# JONES & BEACH ENGINEERS INC.

**RE: Response Letter – Peer Review**  
**635 Sagamore Ave, Portsmouth, NH**  
**Tax Map 222, Lot 19**  
**JBE Project No. 18134.1**

We are in receipt of comments from Eric Weinrieb, P.E., Altus Engineering dated June 4, 2024. Review comments are listed below with our responses in bold. In addition to the below comments, the City DPW requested two changes to the plans and drainage model at an on-site meeting with Mike Garrepy of 635 Sagamore Development, LLC on July 24<sup>th</sup>, 2024 while the new test pits were being dug.

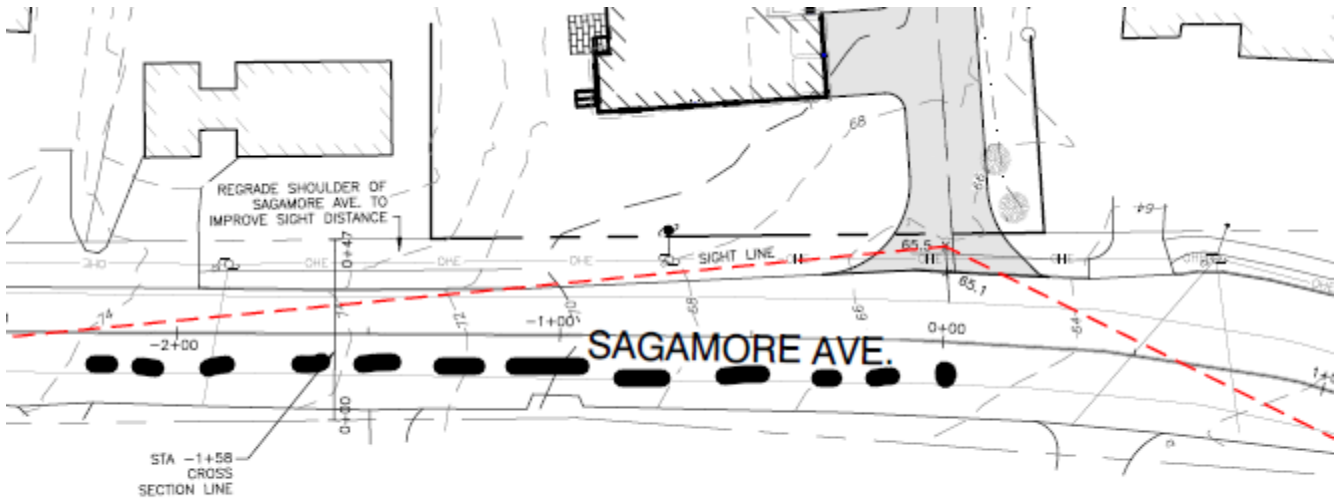
Looking at the plans, it appears that the sight line was plotted along the red dashed line. However, this line would represent the intersection sight line and not the stopping sight line. The 2-foot object height for stopping sight distance needs to be at a point in the travel lane, not at a point 14.5 feet from the edge of the travel lane. Stopping sight distance is for approaching vehicles to be able to see and react to a vehicle stopped in Sagamore Ave waiting to turn left into the site driveway. I don't know how much of a difference, if any, the location of the 2-foot object will have on the sight lines, but it needs to be shown and the report updated to reflect the proper location.

The black dotted line in the figure below illustrates where the 2-foot object should be located.

Plan Name: **EXISTING WATERSHED PLAN**

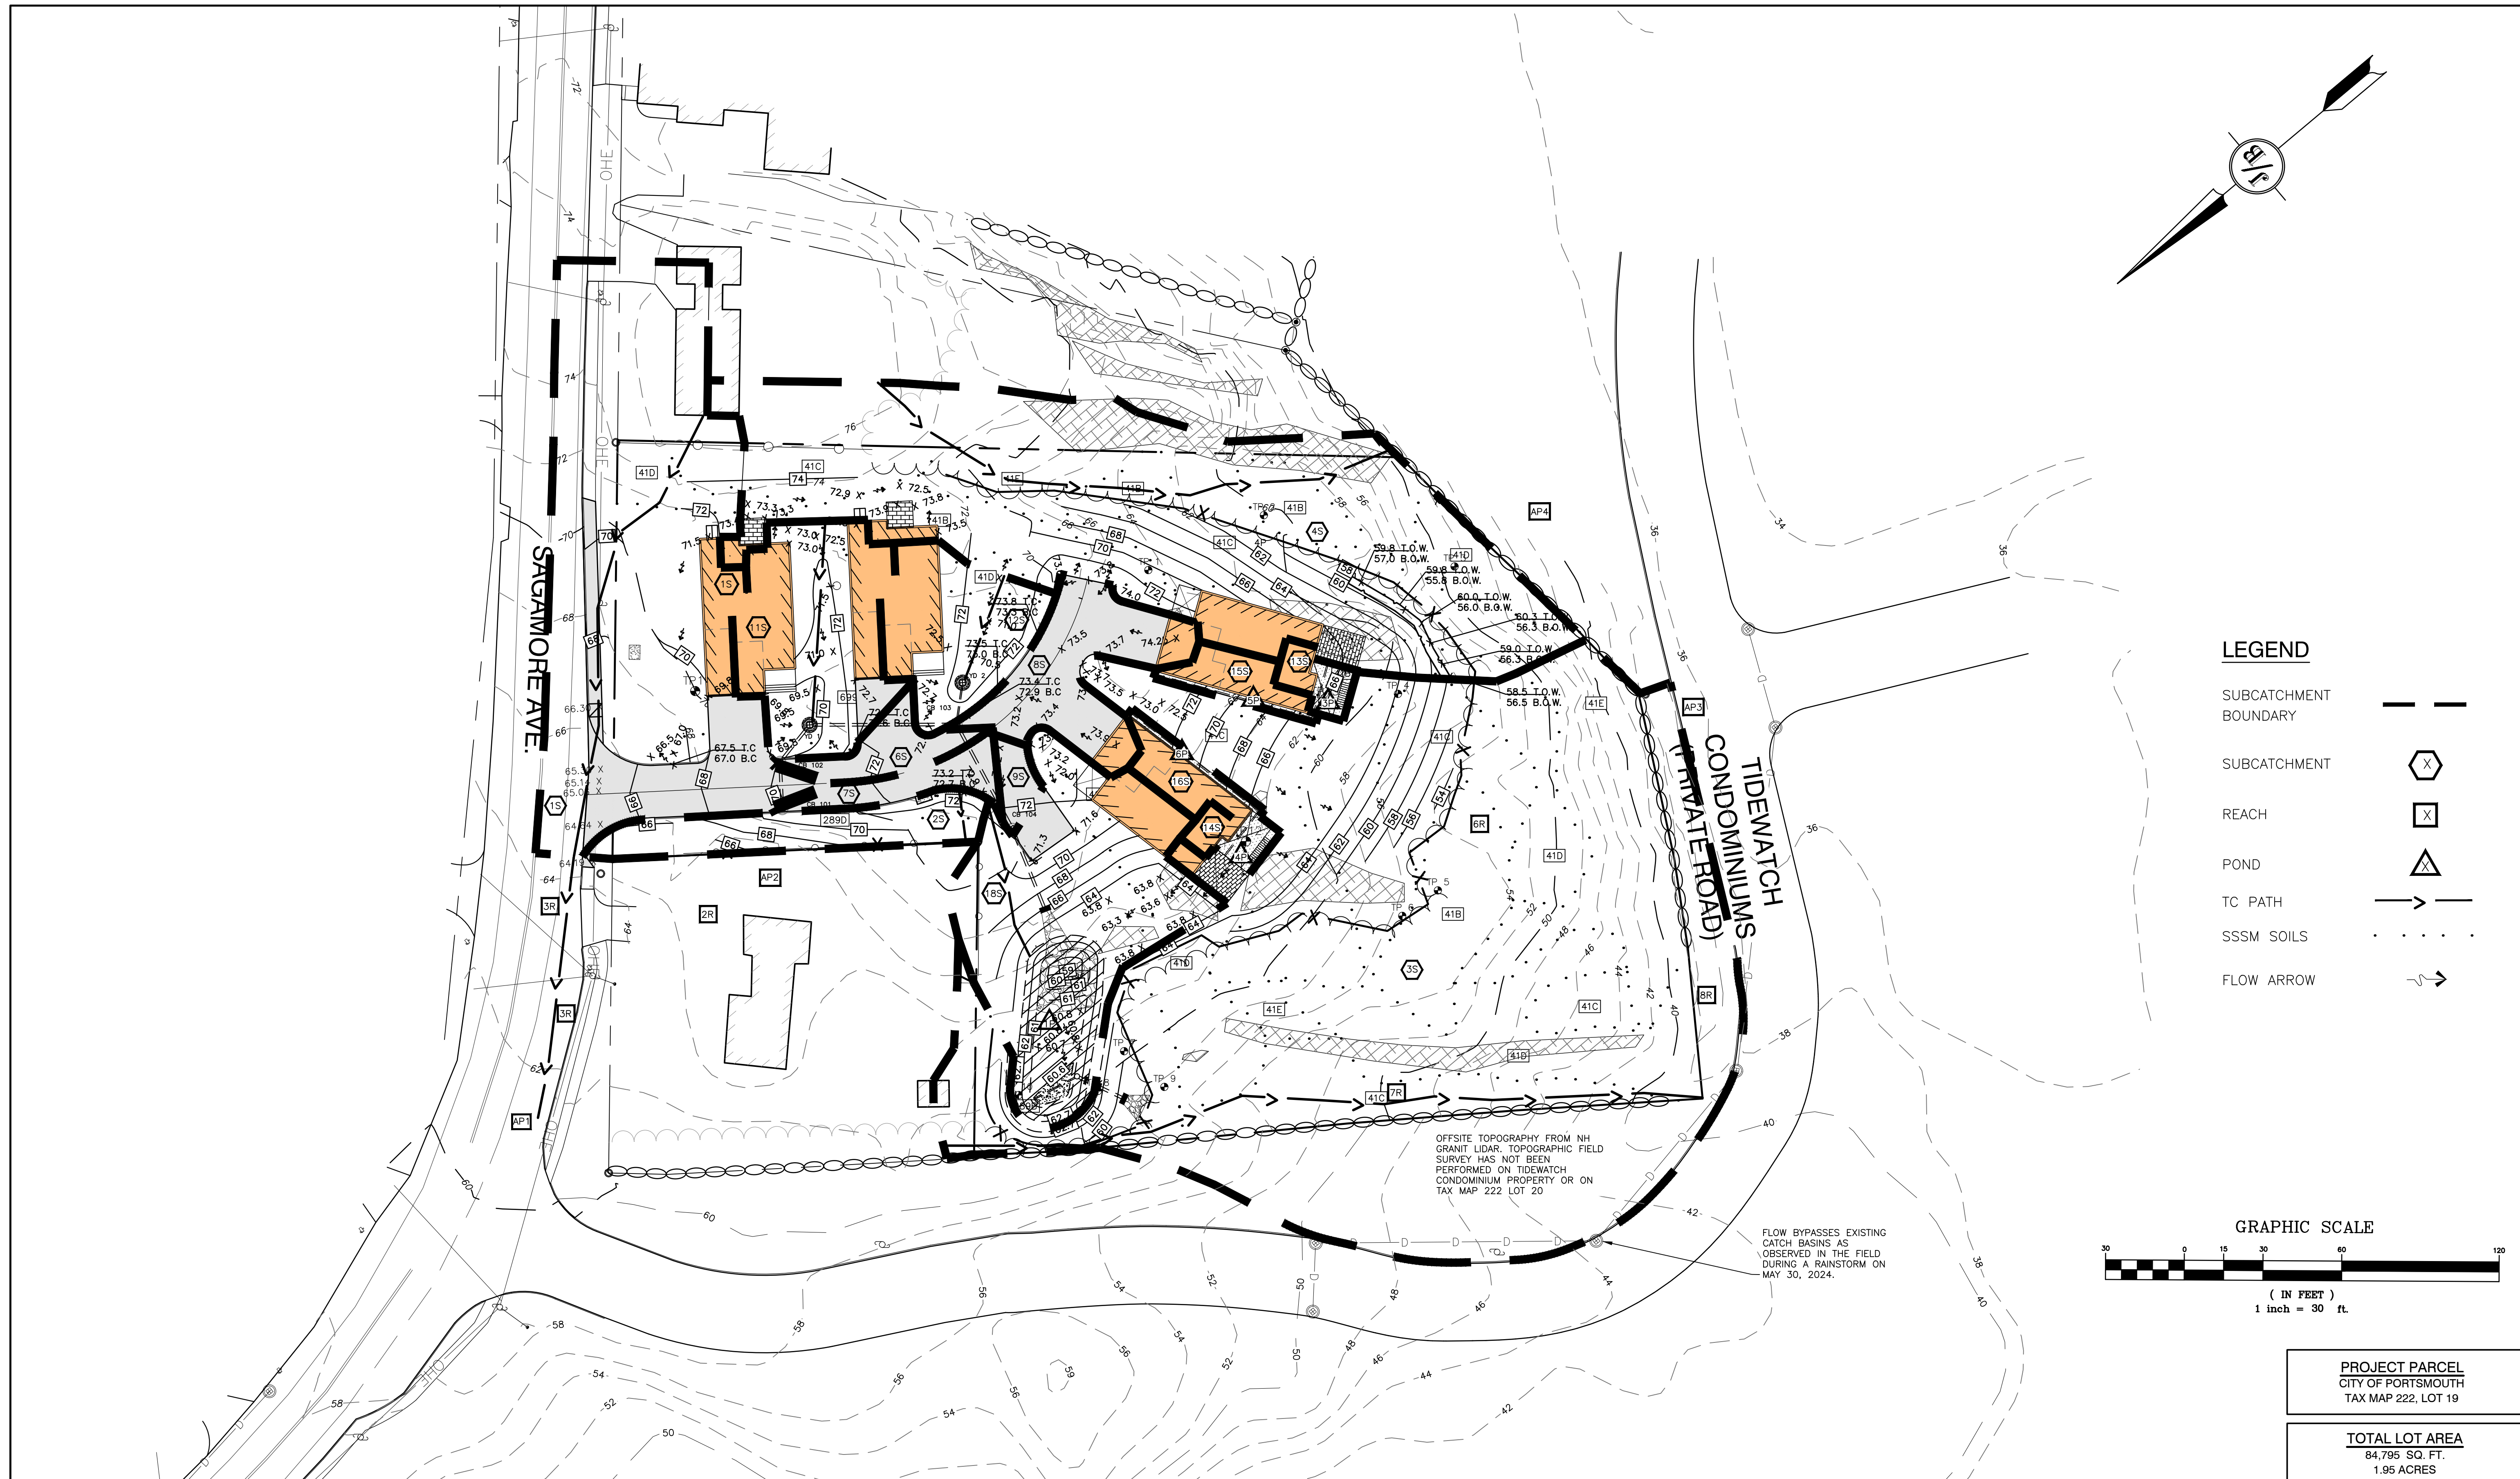
23. It is Altus' opinion that the longest flow path shown on the plans for both subcatchments 3S and 4S are underestimated. The Designer should confirm their assumptions.

25. *The watershed plan indicates that the off-site topography is from NH Granit lidar. The plans should include the off-site topography for the portion of the Tidewatch condominium roadway and the northerly abutter's property.*

**RESPONSE: We ran other flow paths in HydroCAD and it turns out that our originally selected Tc paths for both of these subcatchments actually are the longest flow paths. The existing watershed plan shows the other candidate Tc paths within subcatchments 3S and 4S along with the resulting times of concentration. We have also reviewed and confirmed the modelled lengths and slopes for the Tc paths for both of these subcatchments.**

**RESPONSE:** NH Granit lidar topography has been added for the portion of the Tidewatch Condominium roadway nearest the subject parcel and for the northerly abutter's property.
